IRF21/1205

Alteration of Gateway determination report – PP_2019_RANDW_002_00 (PP-2020-75)

Expansion of the Eastern Suburbs Memorial Park
(cemetery and crematorium)

Figure 5. Estimated yield of lawn and monumental burial plots. Source: Revised Concept Plan, by MHLA, issue D, dated 8/9/2020.

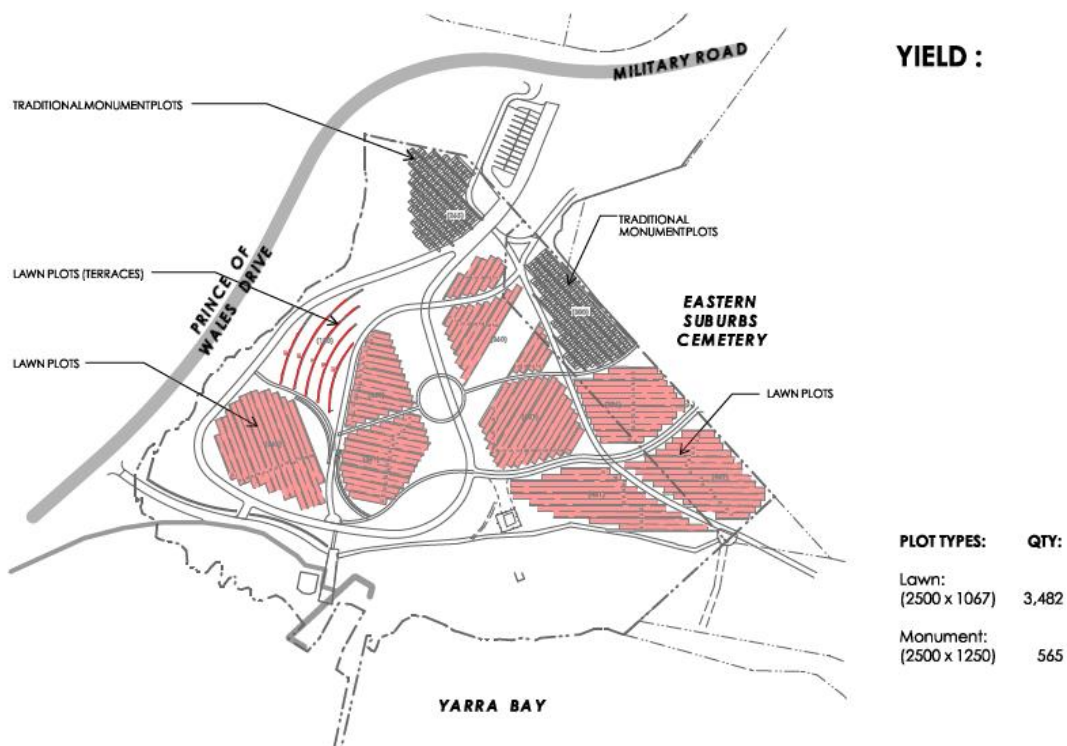
It is noted that Condition 1 (d) is partly satisfied as the revised Concept Plan provides a revised estimated number of burial plots (lawn – 3,482 and monument – 565) however the estimated ash interment space remains unclear (**Attachment C1**). Any future planning proposal will require consistency in the estimated number of burial plots and clarity in ash interment space in all technical and supporting documentation.

It is noted that Conditions 1 (e) and (f) have not been addressed in the February 2021 submission.

Gateway Condition 1 (d) and (e) require updated information of the estimated numbers of burial plots and ash interment space to reflect the changes to the Concept Plan and confirmation as to whether the 3,000 burial plots include the 125 burial plots for Aboriginal cemetery.

Figure 6. Extract from revised Section A, issue D, which denotes the MHW and the vegetation/beach transition zone (red box). Source: Revised Concept Plan, by MHLA, dated 8/9/2020, Attachment C1.

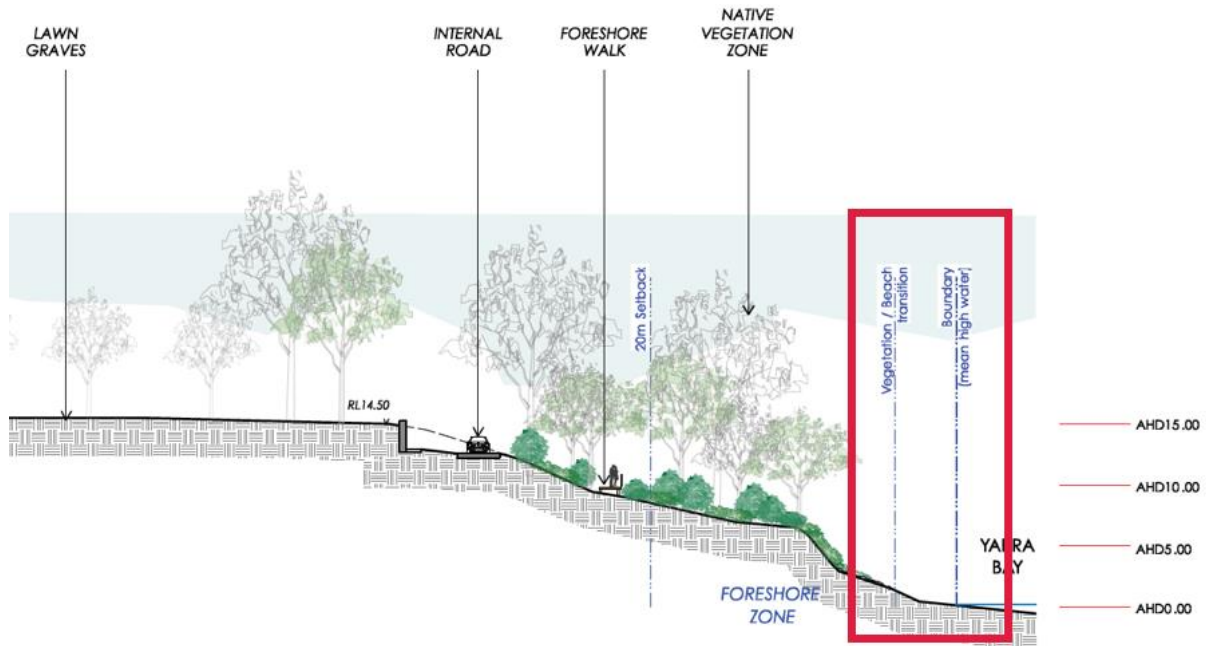
- An explanation in plain English has not been provided as to how the ‘Foreshore Vegetation Zone’ (FVZ) is determined, as well as its relationship and inter-dependencies with the Coastal Hazard Zones and buffer zones for burial areas. This is required to clearly explain how the setbacks to burial areas and walkways have been determined to mitigate impacts from future coastal hazards and potential contaminated groundwater seepage, as well as to provide a landscape corridor for planting and native vegetation retention.

- The above should be supported by clear maps and illustrations. As discussed above, the revised masterplan and sections do not clearly show the width of the FVZ and how this zone is determined. Written clarification should be provided in addition to a revised masterplan.

- Formal engineering advice with supporting evidence is required to explain why the coastal hazard lines do not extend over the south-western part of the site. This is to demonstrate the capability of the proposal in ensuring public safety, especially for users of the walkways and cycleways. The February 2021 submission only includes a short email correspondence from the engineering consultant.

The above requirements may result in changes to the extent or alignment of the Additional Permitted Uses Map (for ‘cemetery’ purposes) and the concept master plan.

Figure 7. overlay of additional permitted use (pink) with the lot and DPs of the site

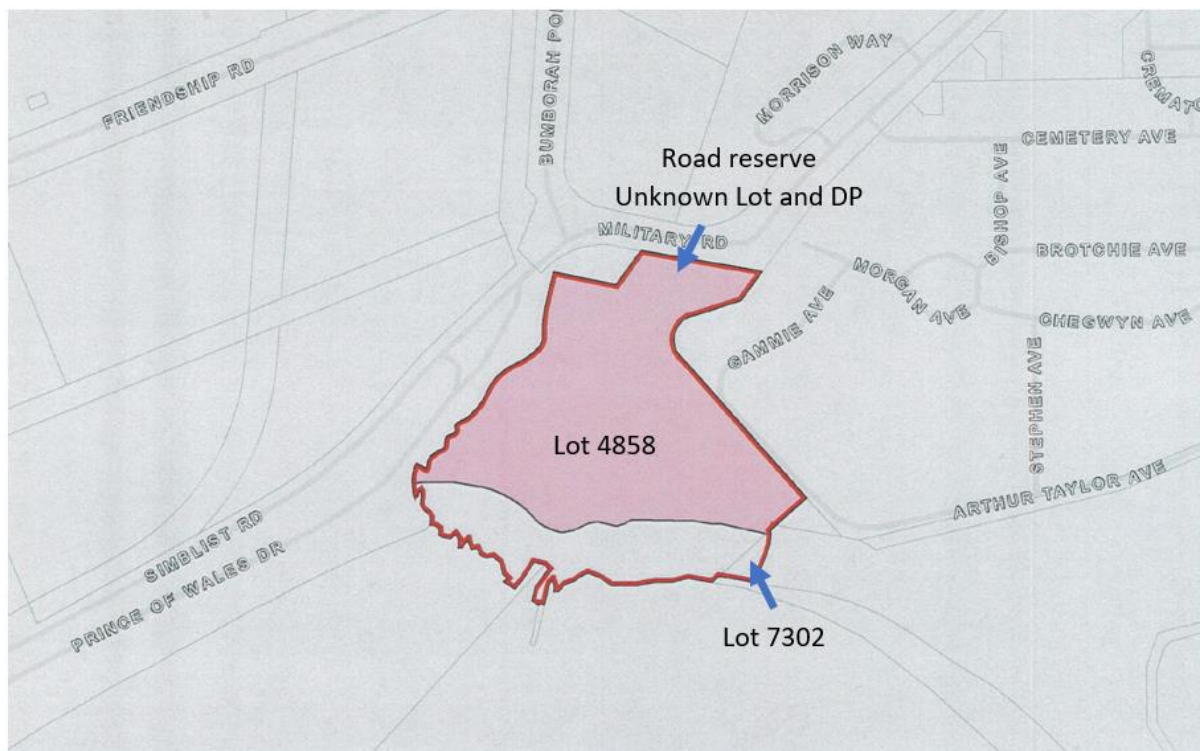
As detailed in Section 1.1.2 of this report, the Deed of Agreement associated with the ALCs over Lot 4858 requires 125 burial plots for the Aboriginal Cemetery and Condition 1 (e) requires confirmation of whether the estimated number of burial plots includes the 125 burial plots for Aboriginal cemetery. It is noted in Section 4.2.2 that this Condition is not yet addressed.

According to Crown Lands' records and advice, five ALCs made by the La Perouse and NSW Local Aboriginal Land Councils remain outstanding for Lot 7302, a triangular lot at the south-east corner of the site. The Additional Permitted Use map does not appear to apply to Lot 7302 (**Figure 7**), however, any future planning proposal needs to clarify whether it affects Lot 7302. Council should consult with Crown Lands to ensure the appropriate authorisations are in place and processes are followed with regards to the remaining ALCs on Lot 7302 before a planning proposal is lodged.
